NOTICE OF MEETING
PLANNING AND ZONING COMMISSION
6:00 P.M. – May 14, 2020

PLANNING AND ZONING COMMISSION ITEM:
PC-19-20
PRELIMINARY PLAT
CIBOLO CLIFF RANCHES

Halff Associates, on behalf of the City of Bulverde, has performed a review on the Cibolo Cliff Ranches Preliminary Plat, dated May 1, 2020 and supporting documents. The review was conducted relative to the requirements established in the current Subdivision Ordinance and Drainage Design Criteria Manual (DDCM, January 2019). The following items were reviewed, resolved items noted in blue. Based on our review of the referenced documents, Halff Associates has no further comments and recommends approval of the Cibolo Cliff Ranches preliminary plat at the next available Planning & Zoning meeting.

INDEX MAP DETAIL

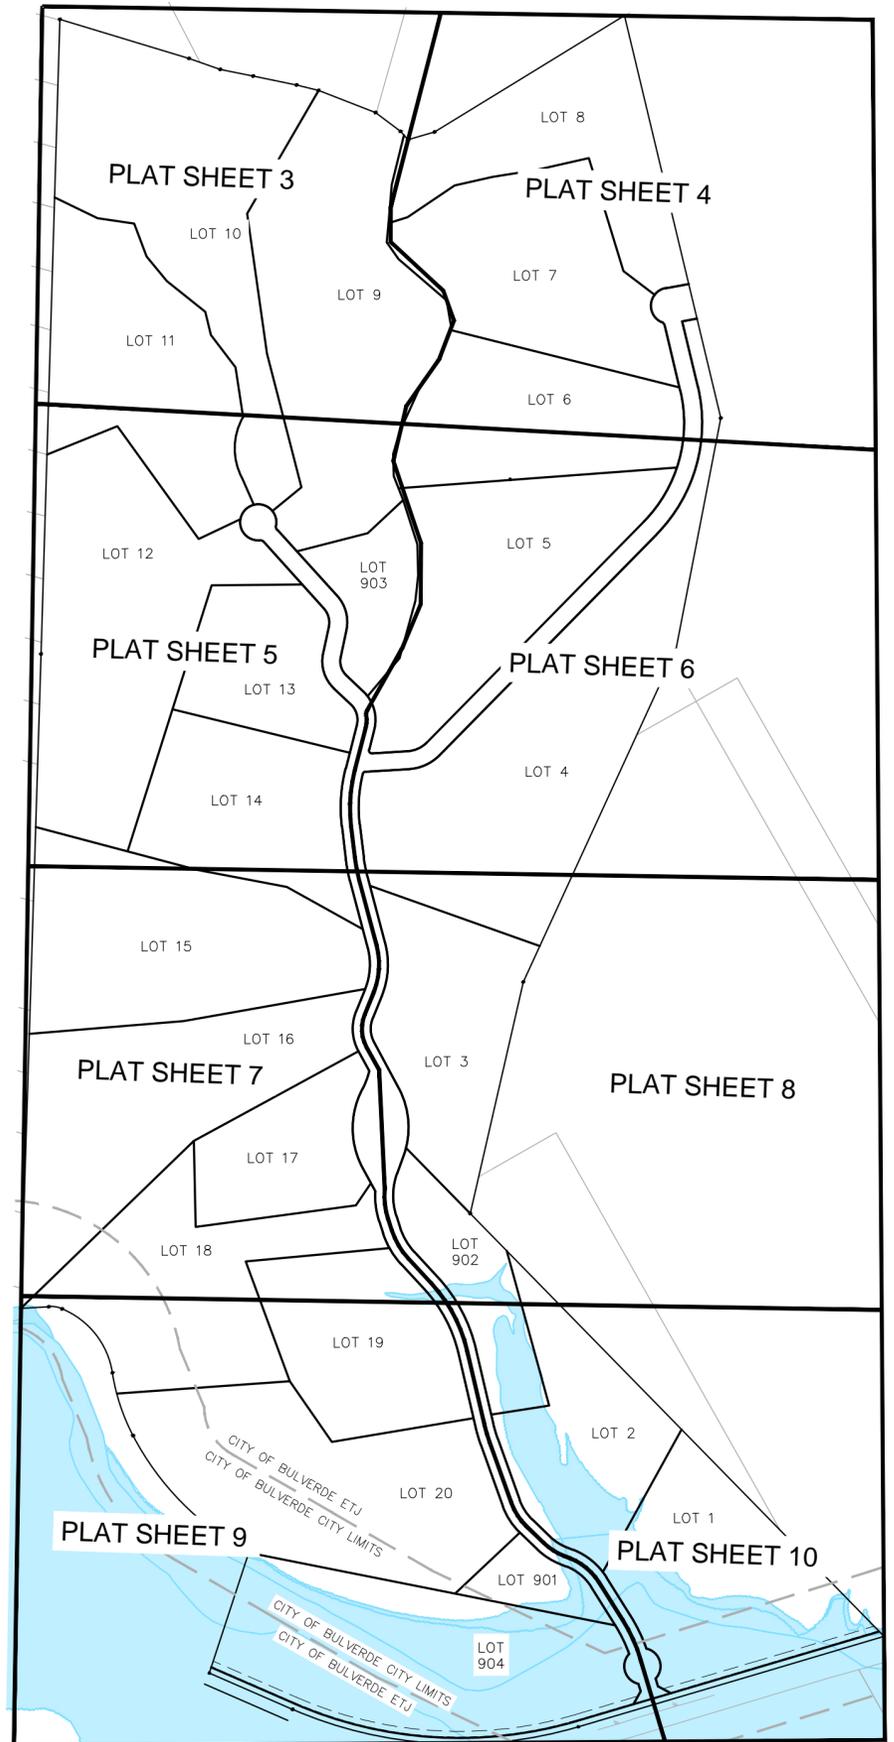
8. A minimum of two corners of the subdivision referenced to State Plane Grid Coordinates. – [comment resolved](#)
9. Show city limits and limits of the City's ETJ on location map and plat (i.e. FM 1863) – Plat shows and labels City Limits on Sheets 9 & 10, shows City Limits on Sheet 7 but not labeled. Not shown on Location Map (Sheet 1), Shown but not labeled on Index Map (Sheet 2) – [comment resolved](#)

- 43. Label ALL lots including open space lots on Index Map (Sheet 2 of 10) – [comment resolved](#)
- 44. Confirm label Lot 902 or 904 between Sheets 2 and 9 of 10 – [comment resolved](#)
- 45. Missing Distances on lot boundary lines (Check sheets 3-10 of 10) – 4/30 Comment: Still missing some distances on boundary lines. Check and verify all Lots, Easements, ROW, etc. has bearings and distances shown to determine limits of each boundary. – [comment resolved](#)
- 46. Acreages for lots are inconsistent between sheets – 4/30 Comment: Still some inconsistency. (See Sheet 3 & 5, Lot 10). Check and verify all Lot and Easement acreages – [comment resolved](#)
- 47. Lot Numbers are inconsistent between sheets – [comment resolved](#)

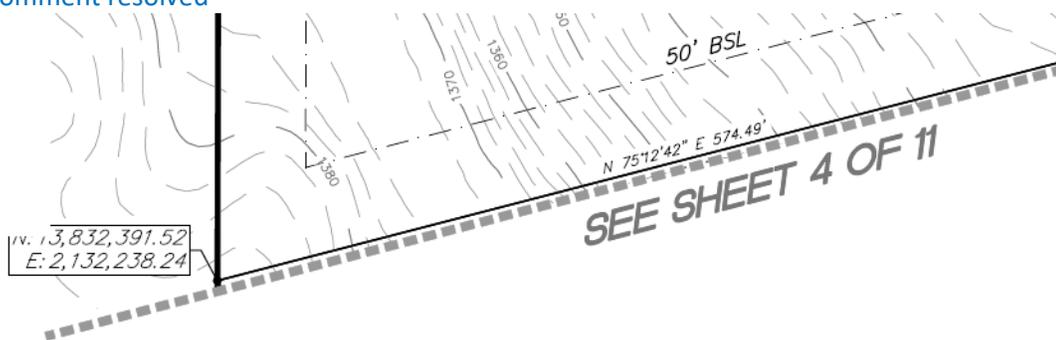
31. The way hydrology is calculated is a little unusual for the unit hydrograph method. Typically, time of concentration and Curve Numbers are calculated for each individual sub-basin and then routed through the main channel. What is shown is not technically wrong, just over simplified. This is probably why a Tc flowpath was not shown on the drainage area map for Area A5, A6, A7 and A8. 12/10 Comment: Missing attachments in drainage report....could not verify revisions. – [Comment resolved...methodology updated and makes more sense.](#)
